Proposed changes to 178A.1.11

(comment #327)

IEEE P802.3dj Task Force

September 2024 (r0)

MLSD gain is a function of the calculated operating point

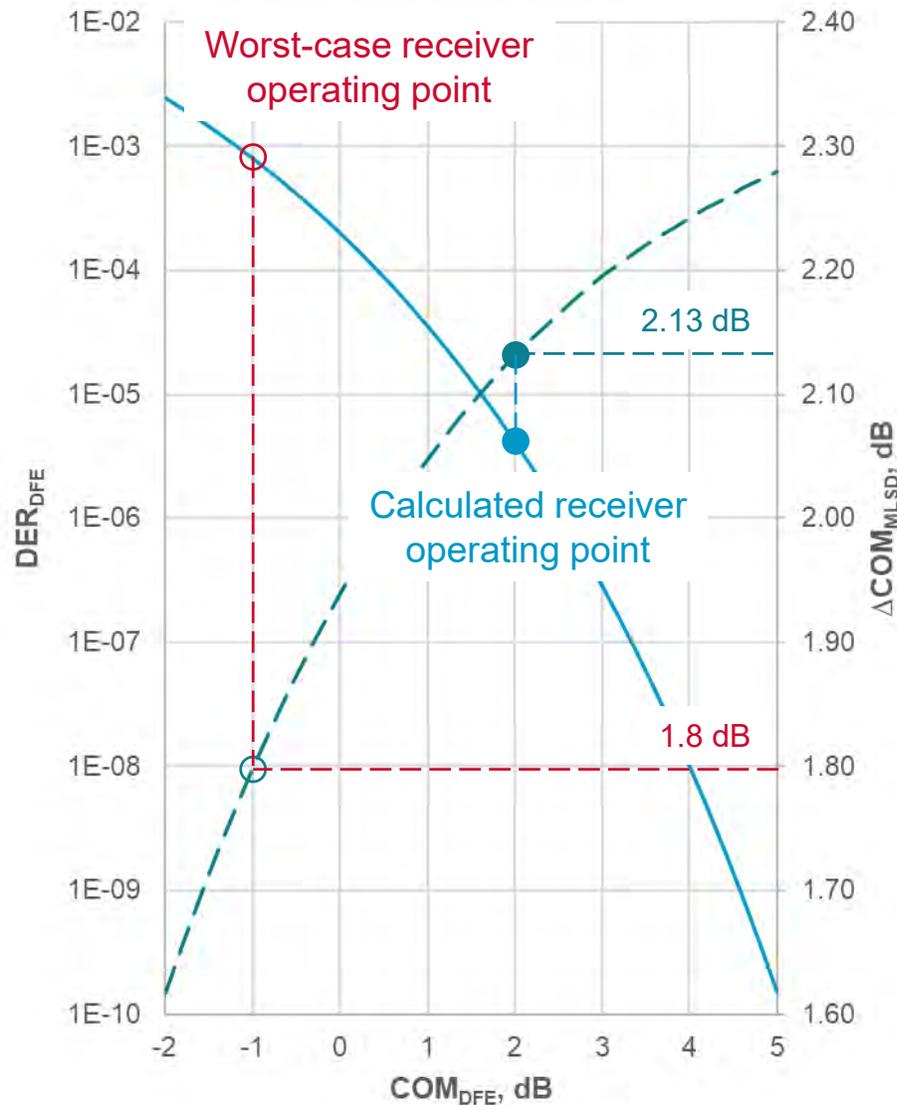
- The effective gain of the MLSD-based reference receiver is related to COM_{DFE}
- In the region of interest, the MLSD gain tends to increase with increasing COM_{DFE}
- This MLSD gain is currently computed using the calculated receiver operating point
- However, the calculated receiver operating point is optimistic
- It enforces margin to allow for impairments that are not included in the calculation
- The MLSD gain should be calculated based on the worst-case operating point which accounts for the consumption of this margin

Overview of the proposed changes, 1 of 4

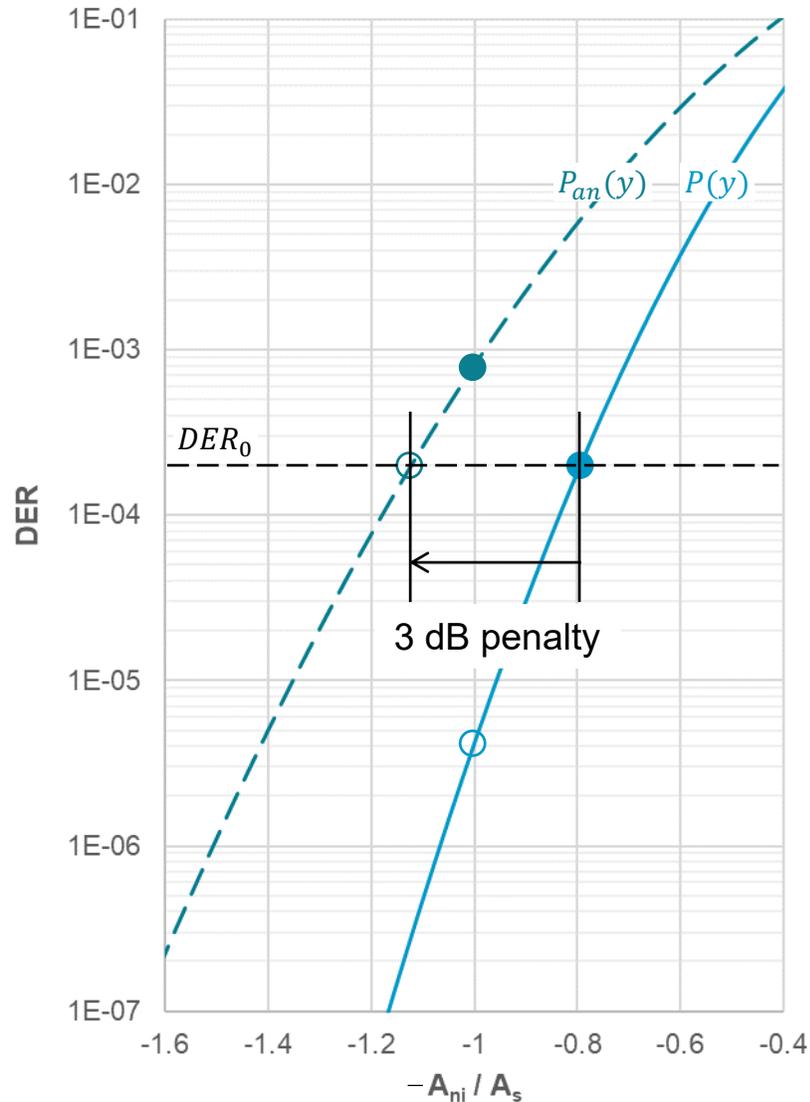
- Compute COM_{DFE} from the cumulative distribution function of noise and interference amplitude $P(y)$ as currently defined in the draft

Overview of the proposed changes, 2 of 4

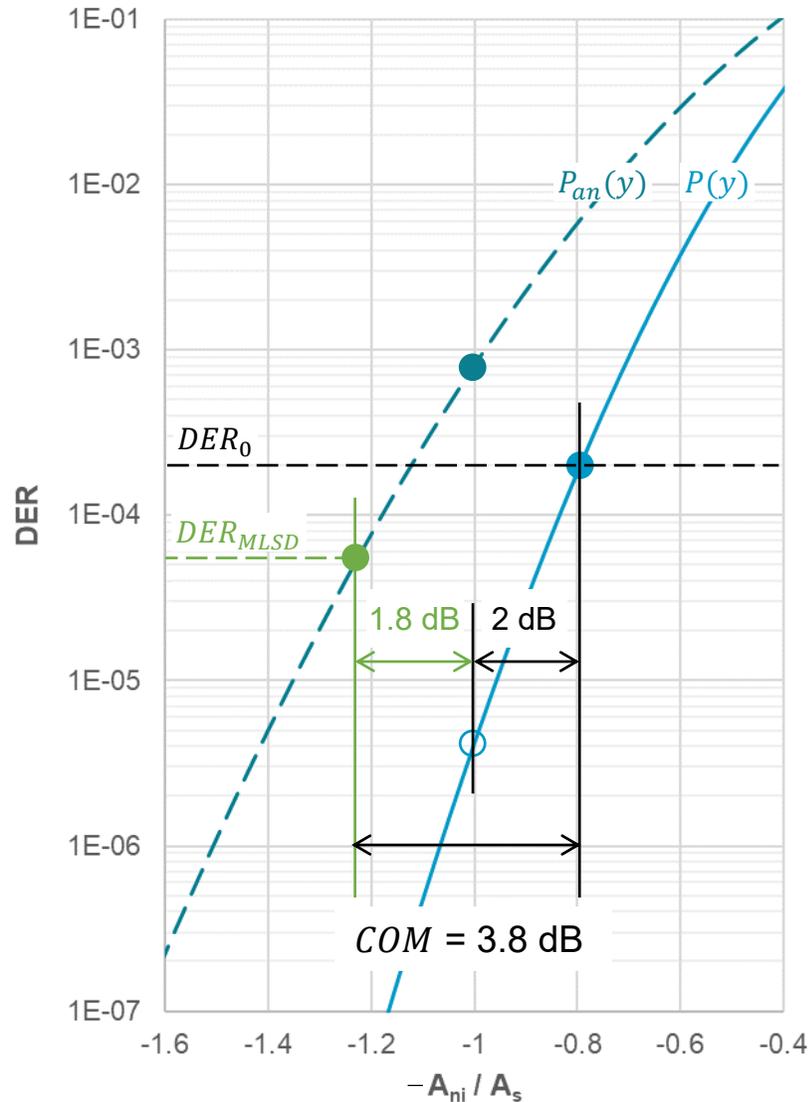
- Define a new cumulative distribution function $P_{an}(y)$ that is $P(y)$ with additional noise
- The additional noise represents impairments allowed by the minimum COM limit but not explicitly included in the calculation of $P(y)$
- This is not an “implementation penalty” for MLSD
- It is included so that the MLSD gain is calculated in the correct context

- Note that a corresponding adjustment must also be made to the power spectral density of the noise and interference
- This is addressed in the list of detailed changes

Overview of the proposed changes, 3 of 4

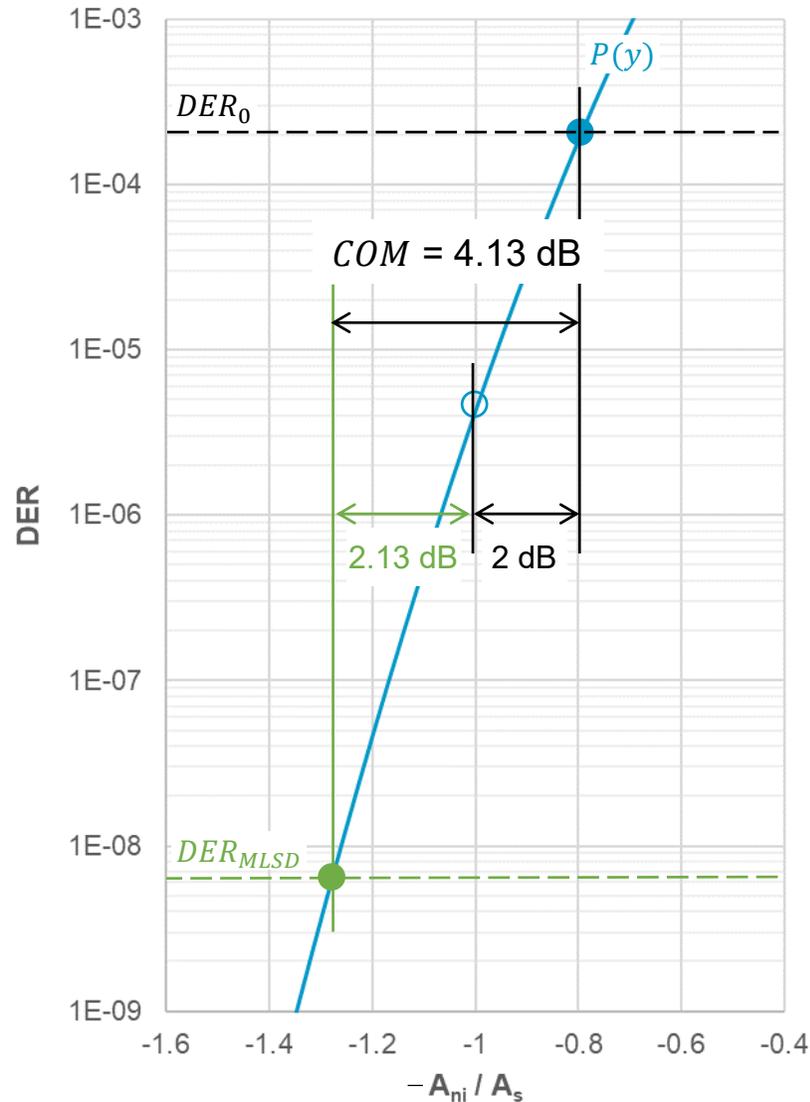
- Compute DER_{MLSD} using $P_{an}(y)$ instead of $P(y)$
- Compute the corresponding MLSD gain

- Apply the gain to COM_{DFE} to yield COM for the MLSD-based receiver

- The resulting value of COM provides the same allowance for additional impairments as COM_{DFE}
- If needed, the COM limit could be increased to allow for additional MLSD-specific impairments

$$\Delta COM_{MLSD} = 20 \log_{10}(-P_{an}^{-1}(DER_{MLSD})/A_s)$$

$$COM = COM_{DFE} + \Delta COM_{MLSD}$$
